NEDO-24011-A, Revision 26,
General Electric Standard Application for Reactor Fuel
(GESTAR II, US Supplement), January 2018

Licensing Topical Report

**General Electric Standard Application
for Reactor Fuel**

(Supplement for United States)

**Figure S-1. Loss-of-Coolant Accident Evaluation Model
(SAFER/GESTR or SAFER/PRIME) Analysis Methods)**

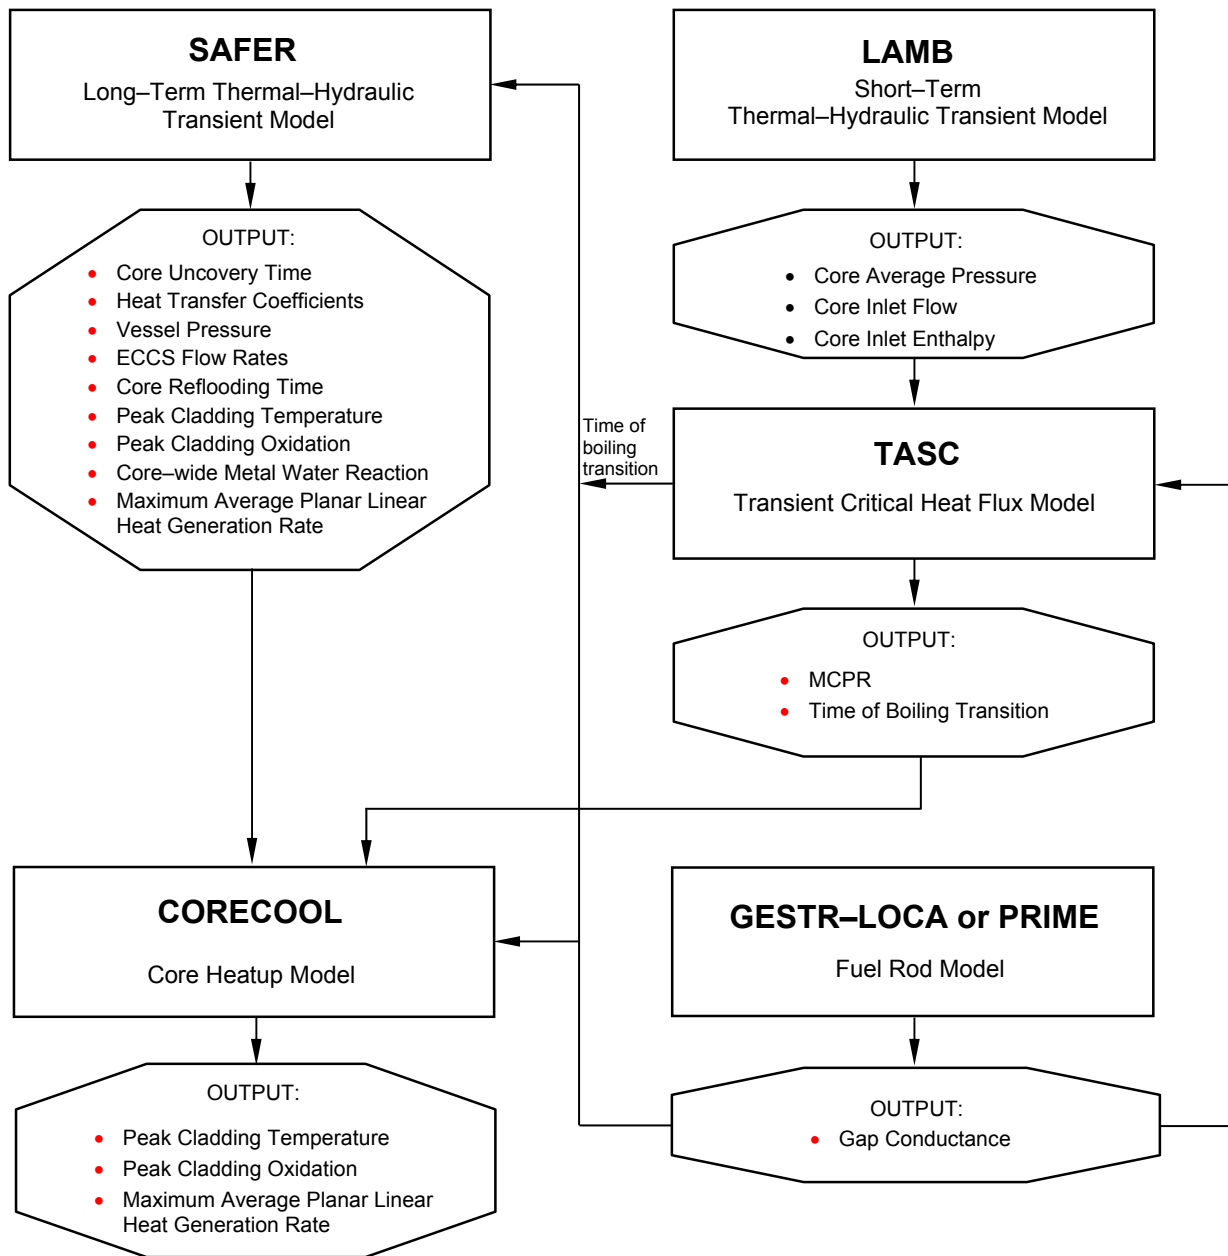
Correct Error in Figure S-2, "Loss-of-Coolant Accident Evaluation Model (SAFER/GESTR Analysis Methods)"

This figure has been updated to reflect the use of CORECOOL code instead of CHASTE for the core heatup model. The use of CORECOOL was approved in NEDC-30996P-A. This LTR has been previously reviewed and approved. The staff agrees that changing this reference in Figure S-2 is an administrative change and therefore is acceptable to the staff.

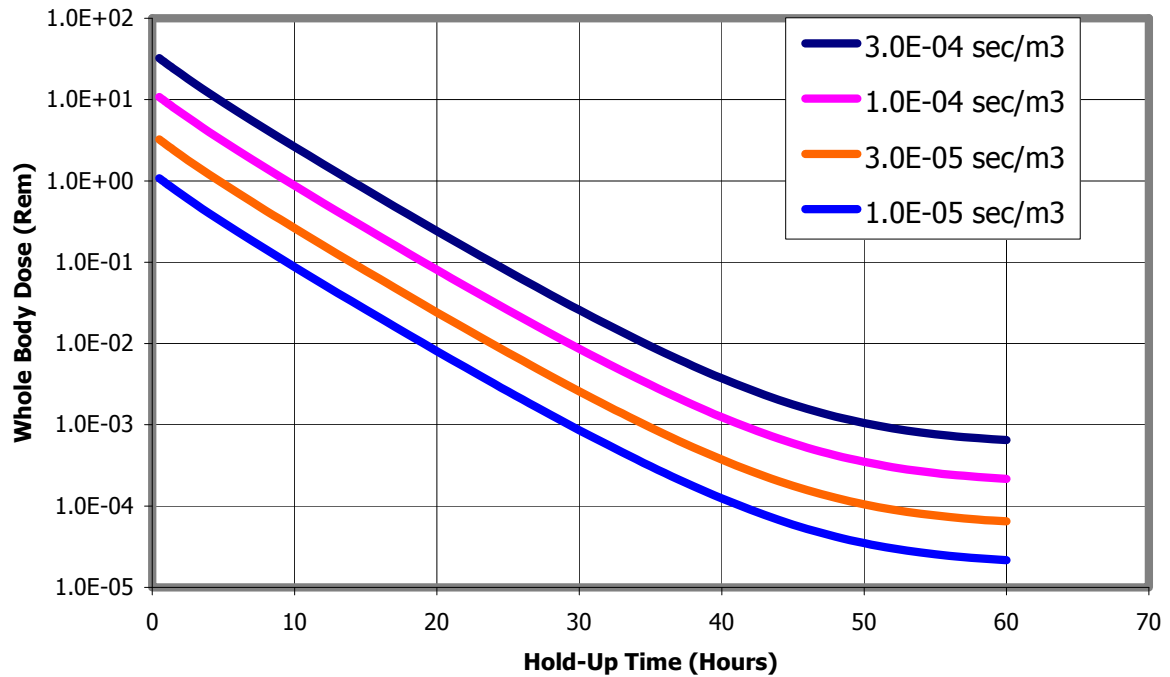
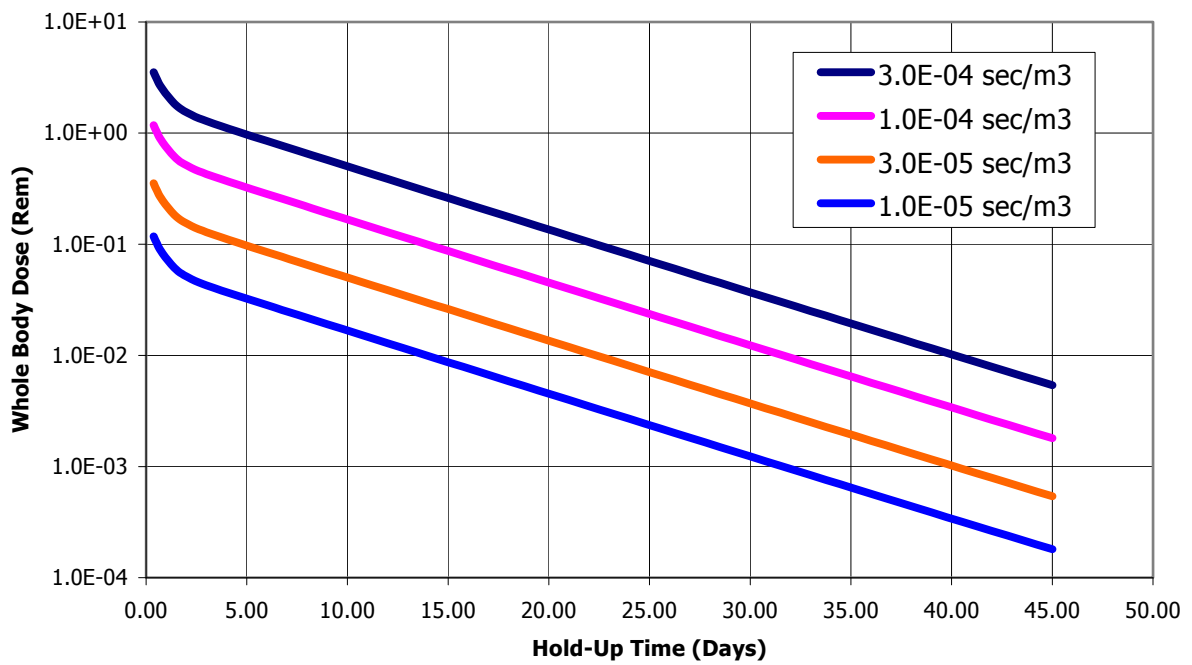
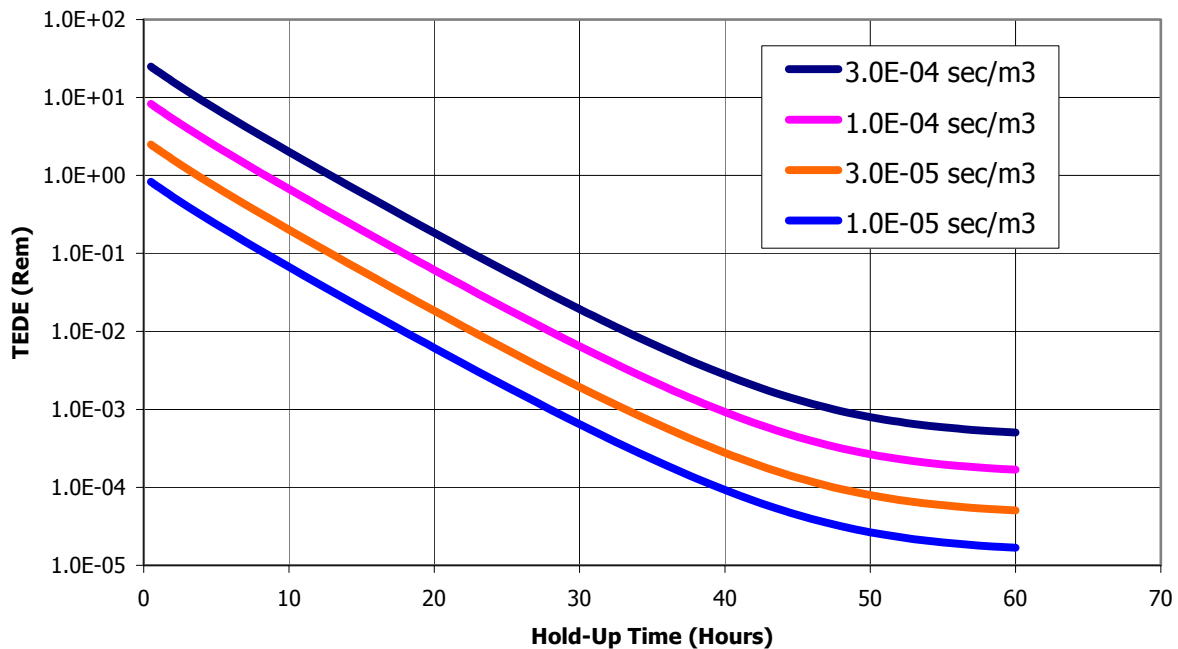
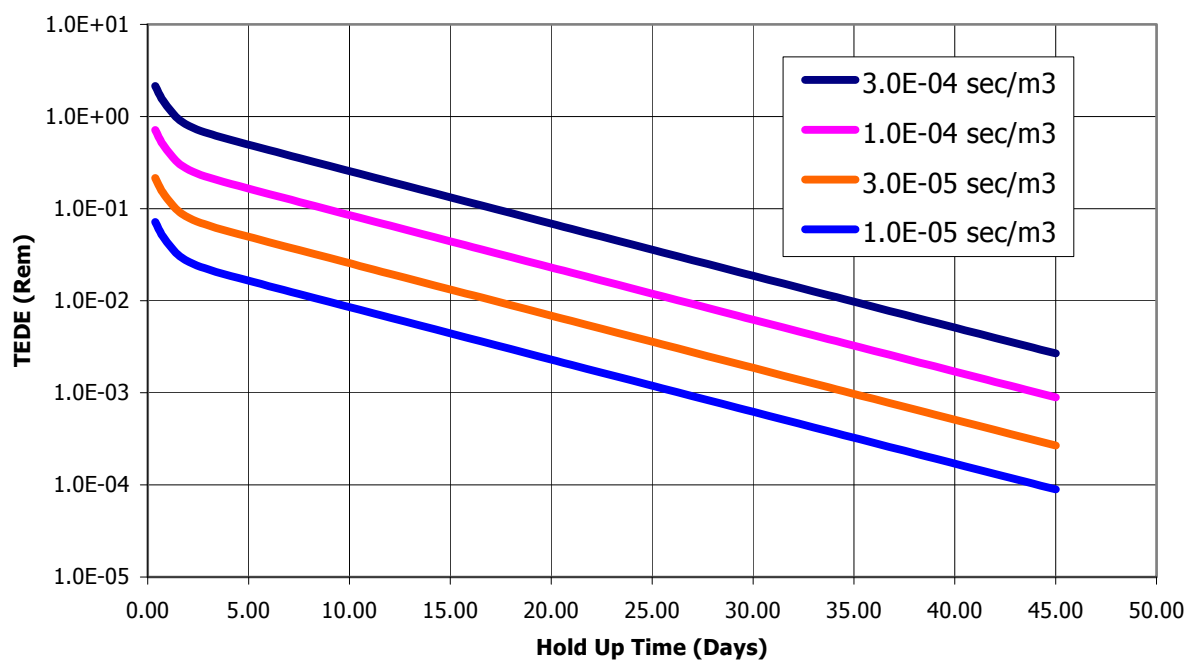
- For accident Scenario 2, please provide the amount of fission products released from the offgas system, resulting doses, and relevant dose calculations for several representative charcoal holdup times in Figures B-2, B-3, B-5, and B-6 of Attachment B.

A sample calculation is provided to show how the curves in Attachment B Figures B-2 and B-3 were generated. The dose conversion factors that were used are as follows:

The resulting Kr whole body dose for a X/Q of 1.0E-04 sec/m³ and an offgas holdup time of 40 hours is 1.24E-03 Rem, which is consistent with the applicable curve in Attachment B Figure B-2.

The resulting Xe whole body dose for a X/Q of $3.0\text{E-}04 \text{ sec/m}^3$ and an offgas holdup time of 40 days is $1.02\text{E-}02 \text{ Rem}$, which is consistent with the applicable curve in Attachment B Figure B-3.

The resulting Kr TEDE dose for a X/Q of 1.0E-04 sec/m³ and an offgas holdup time of 40 hours is 9.24E-04 Rem, which is consistent with the applicable curve in Attachment B Figure B-5.

The resulting Xe TEDE dose for a X/Q of 3.0E-04 sec/m³ and an offgas holdup time of 35 days is 9.75E-03 Rem, which is consistent with the applicable curve in Attachment B Figure B-6.

Figure 5.2-1. Effects of Initial MCPR on ΔCPR Typical BWR Core

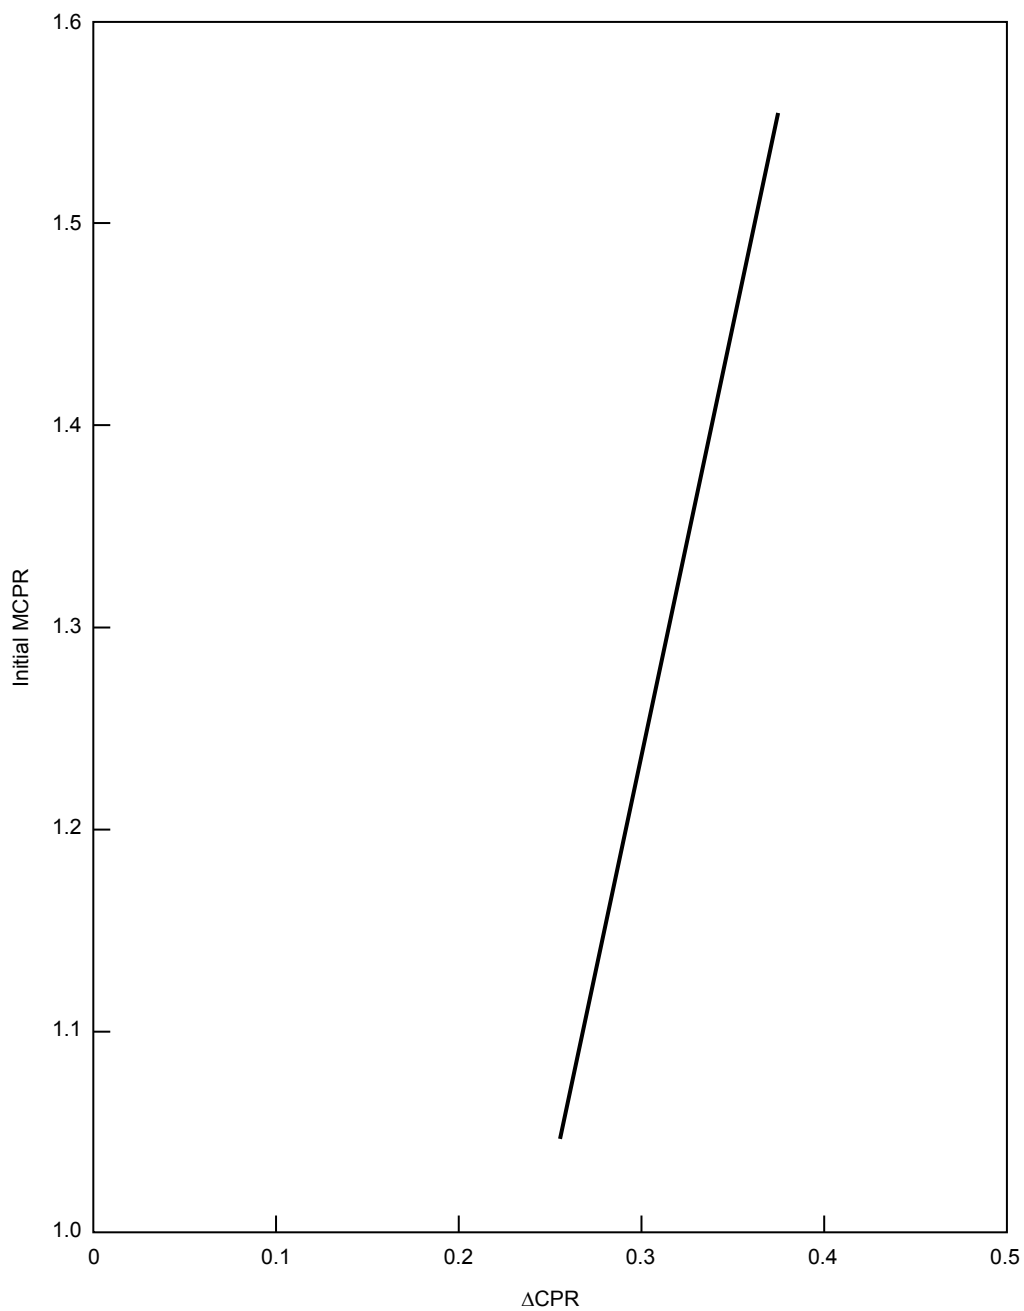
Based on Figure 5.2-1 in Appendix B on page US-6 under S.2.2.1, it appears that the change in ΔCPR versus initial MCPR may be 0.1 versus 0.5 not .01 versus 0.05. Please clarify that the statement is still valid when the change in ΔCPR is approximately 0.01 for 0.05 change in initial MCPR based on Figure 5.2-1 in Appendix B.

Figure 5.2-1 and the associated text in Appendix B of GESTAR II was generated to address an RAI on GESTAR II, Revision 5.

The specific response addressed the transient ΔCPR process and the initial MCPR assumption. Figure 5.2-1 and the discussion in GESTAR show the relative insensitivity of the ΔCPR to the initial MCPR assumption. This figure does indicate approximately a 0.01 change in ΔCPR for a 0.05 change in initial MCPR. The transient analysis process iterates the hot bundle power to achieve an initial MCPR such that the minimum CPR during the transient reaches the SLMCPR. In other words, the limiting transient could start at the OLMCPR and the minimum CPR would be the SLMCPR. Transients that are less severe have lower ΔCPR s, therefore, the initial MCPR in the transient needs to be lower for the transient minimum to reach the SLMCPR. The main point of the original response is to describe that starting non-limiting transients at a lower initial MCPR is acceptable because of the small impact to the ΔCPR . A non-limiting transient can begin the transient at a CPR less than the OLMCPR and have a minimum CPR above the SLMCPR.

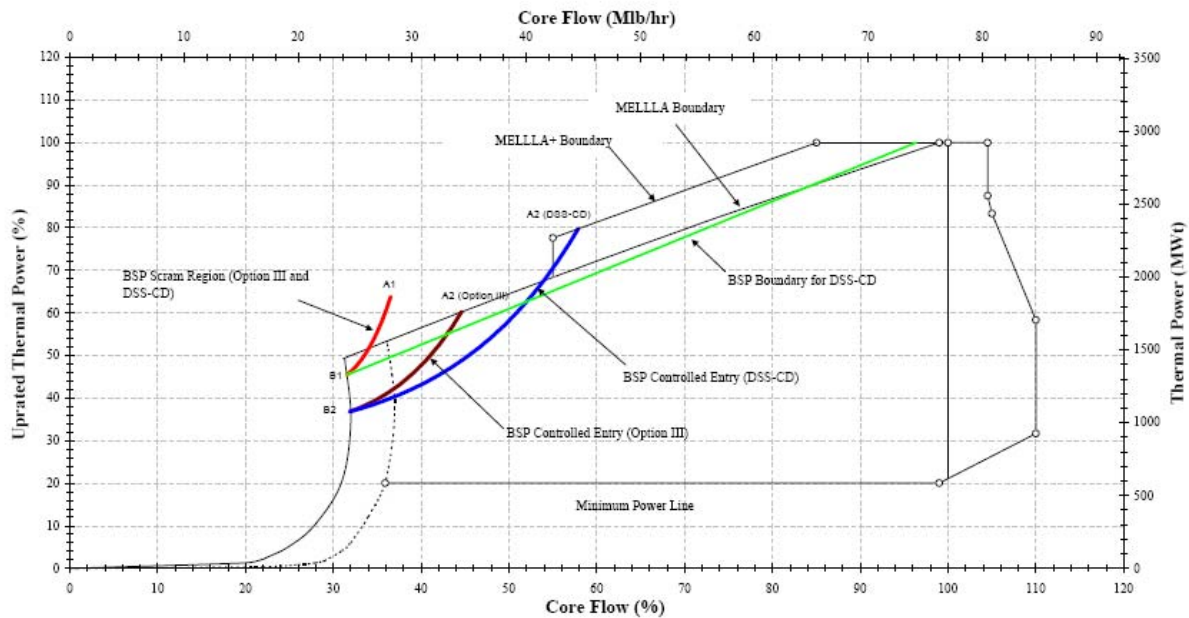
Please provide a power/flow map to show the difference of the domain for Backup Stability Protection (BSP) for DSS-CD under S.4.2.3 and Backup Stability Protection (BSP) for Option III under S.4.2.2, and describe what role Reference S-103 plays to generate a defined exclusion regions.

The calculated stability region boundaries for BSP for DSS-CD and BSP for Option III are shown in the figure below. Please note that the actual implemented BSP boundaries might be larger due to the Base BSP region definitions.

These two BSP methodologies are very similar between the two long-term stability solutions of Option III and DSS-CD. However, two differences exist:
